Subject Final RI Report Replacement Pages

Hi Chris - during preparation of Figures 7-2 through 7-4 of the Draft Feasibility Study (CDM, December 21, 2007), it became apparent that several of the Section 5 figures in the Final RI Report (CDM, November 14, 2007) had not been revised to incorporate final calculations presented in the final Human Health Risk Assessment Report (CDM, November 9, 2007).

Figure 5-1

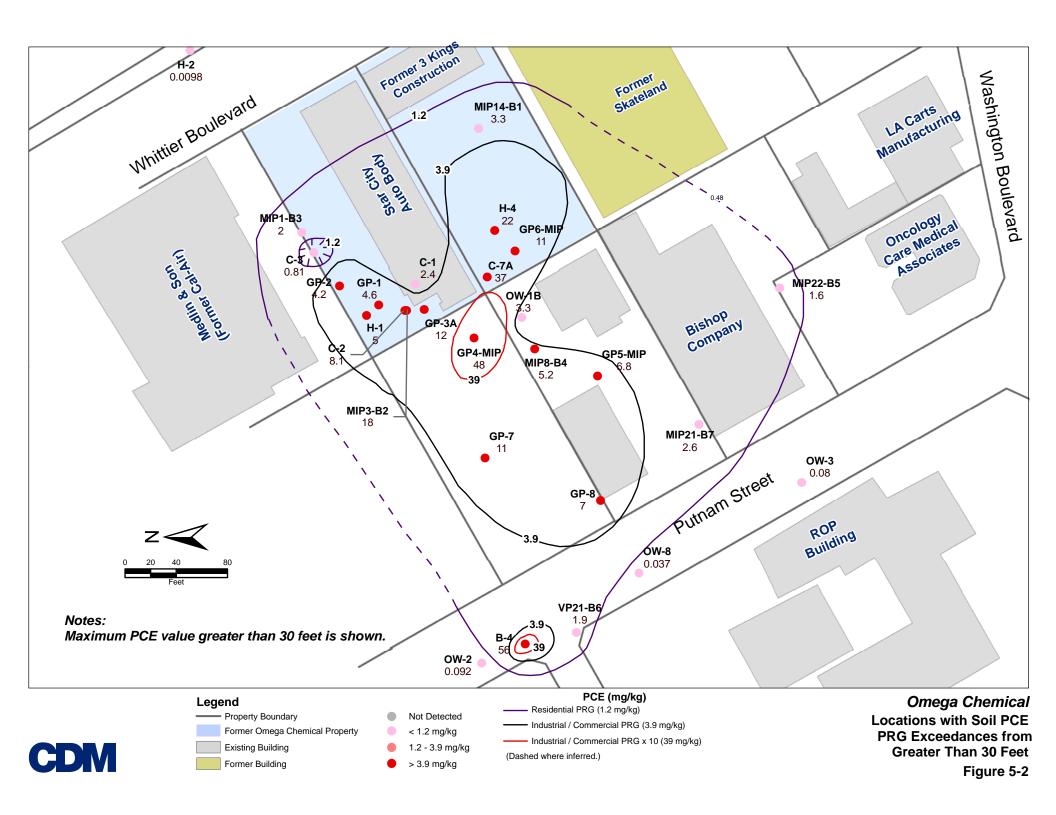
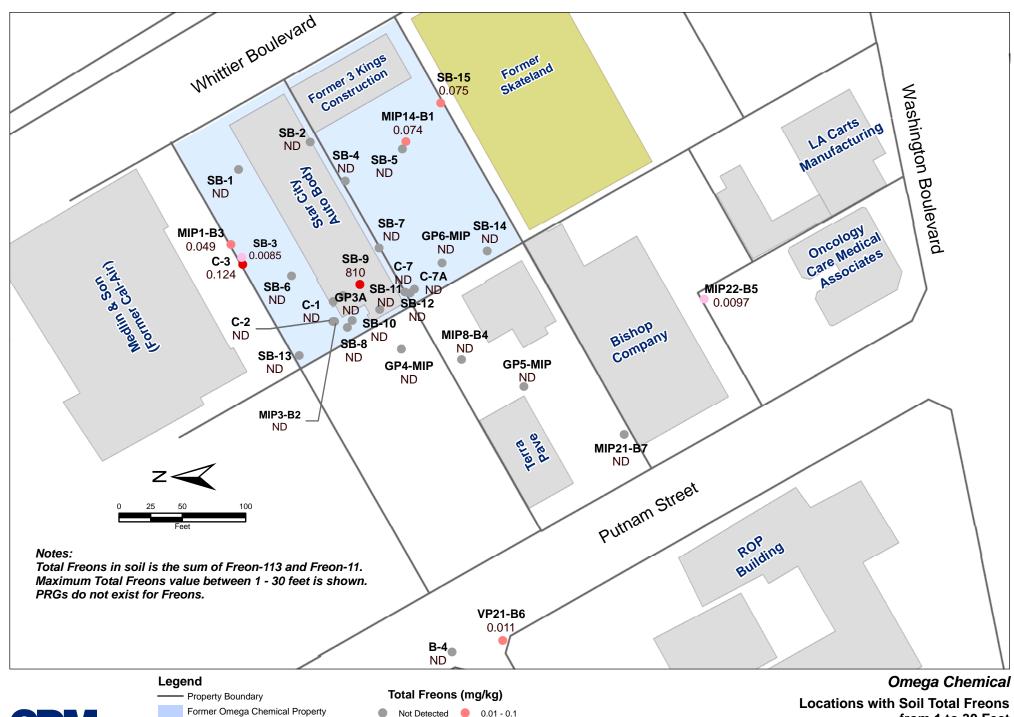
- Figures 5-1 and 5-2 have been revised (PCE PRG values changed and contours redrawn)
- Former Figures 5-3 and 5-4 have been deleted (per email correspondence from Stan Smucker on September 13th, TCE was deleted as a COPC since it was not detected in surface soils. Hence, a site-specific PRG for TCE in soil was not included in the final HHRA)
- Former Figures 5-5 through 5-9 have been relabeled as Figures 5-3 through 5-7
